Habitus Fashion Limited- Extension Building

Gazariapara, Bhawal, Mirzapur, Gazipur

3 September 2024

Observation 2: Missing information in the provided soil test report (Finishing Building).

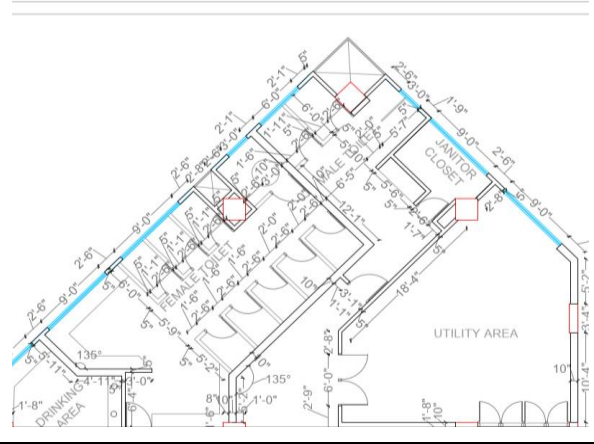
Description: The borehole layout and bore log are not shown in the provided soil test report. The building engineer is required to submit a complete soil test report.

2.	Missing information in the provided soil test report (Finishing Building).	The building engineer is required to submit a complete soil test report. If necessary, update the foundation adequacy in the design report based on the complete soil test report.	within 6 weeks
